International Aero Engines SERVICE BULLETIN

Subject: Transmittal of Revision 1 to Service Bulletin No. V2500-ENG-71-0185

POWER PLANT - GENERAL SERVICES HARNESS (LOOM D) - INTRODUCTION
OF REVISED CLIPPING

V2500-D5

Schematic view of harness loom D
left hand installation before change
Fig 1

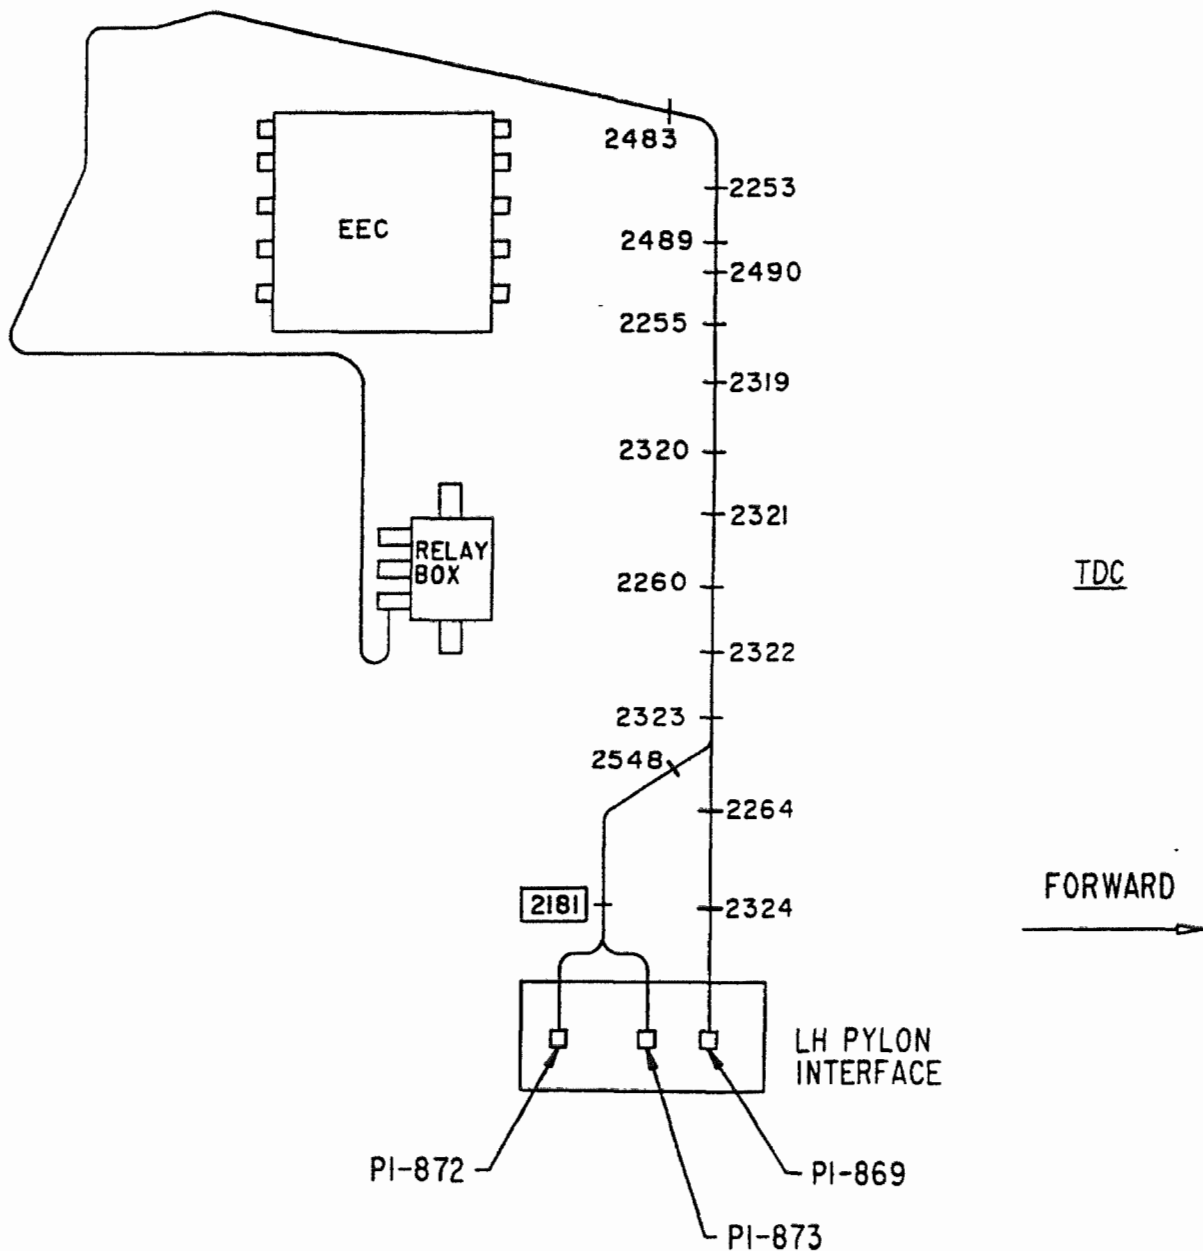
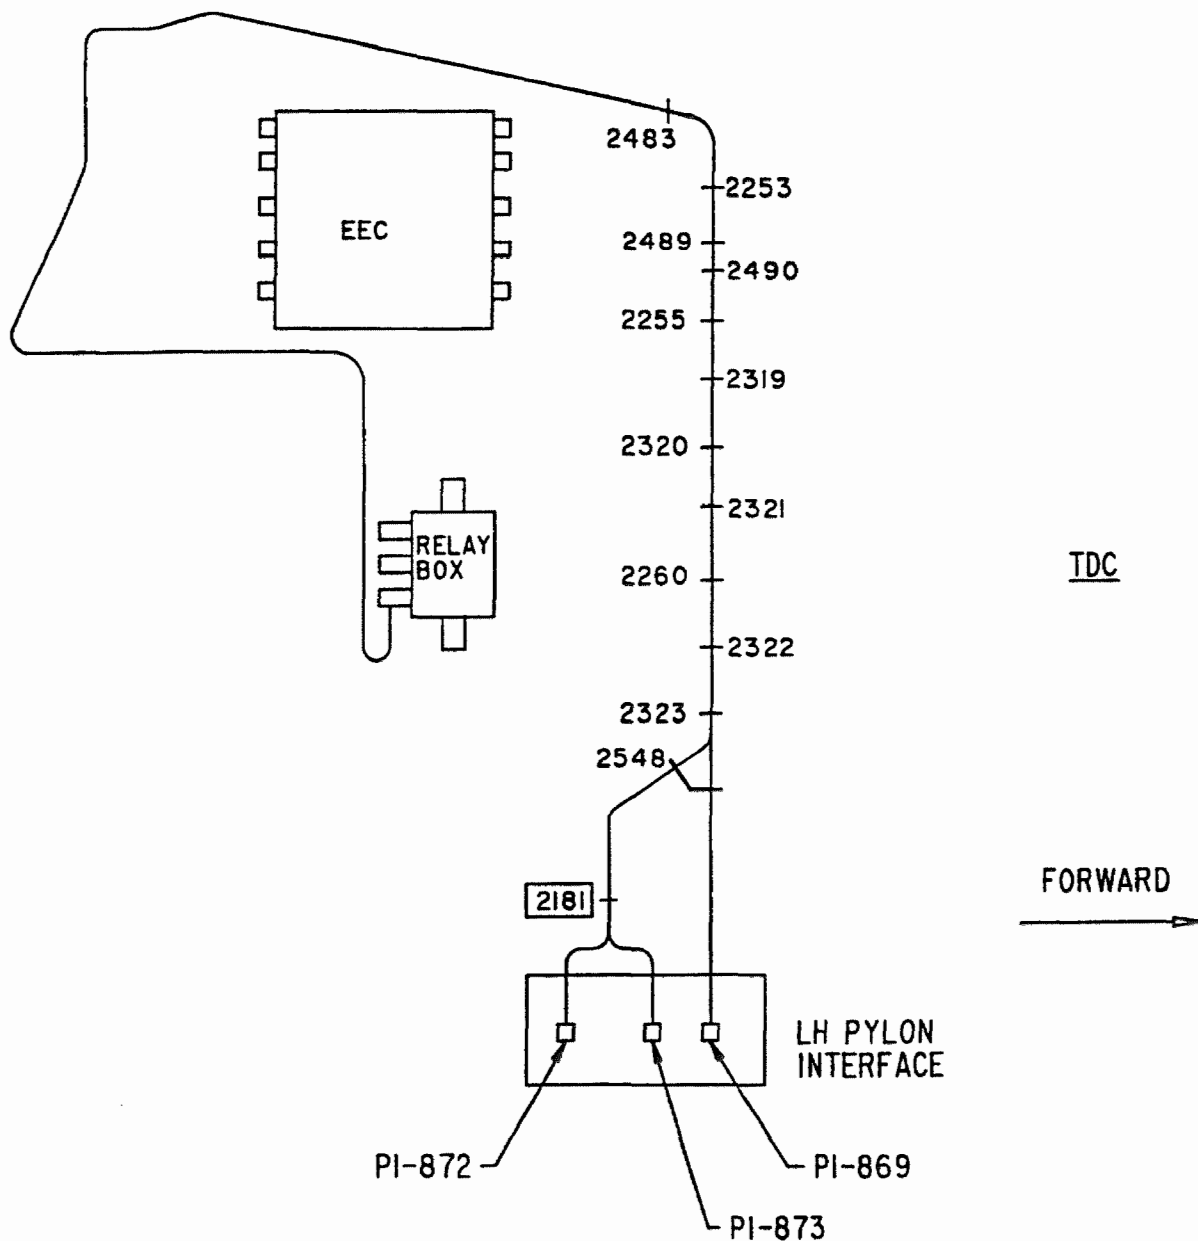
- (1) This Service Bulletin introduces a re-routed General services harness loom 'D' to provide additional clearance with the hydraulic support bracket on the aircraft pylon structure.

(a) Clip points CP2264, CP2324, CP2470 and CP2471 are deleted.

(b) Clip points CP2548 and CP2561 are revised.

- (1) Change the routing of Loom D at the pylon interface. (Refer to the MD-90 Aircraft Maintenance Manual (AMM), 71-51-61, PB401).
 - (a) For the left engine:
 - (i) Remove Loom D from CP2264 and CP2324.
 - (ii) Remove and discard CP2324.
 - (iii) Remove the loop clamp of Loom D from CP2264 (Refer to Fig.5).
 - (iv) With the loop clamp removed from CP2264, attach Loom D to CP2548 (Refer to Fig 4).
 - (b) For the right engine:
 - (i) Remove Loom D from CP2470 and CP2471.
 - (ii) Remove and discard CP2471.
 - (iii) Remove the loop clamp of Loom D from CP2470 (Refer to Fig.9).
 - (iv) With the loop clamp removed from CP2470, attach Loom D to CP2561 (Refer to Fig 8).
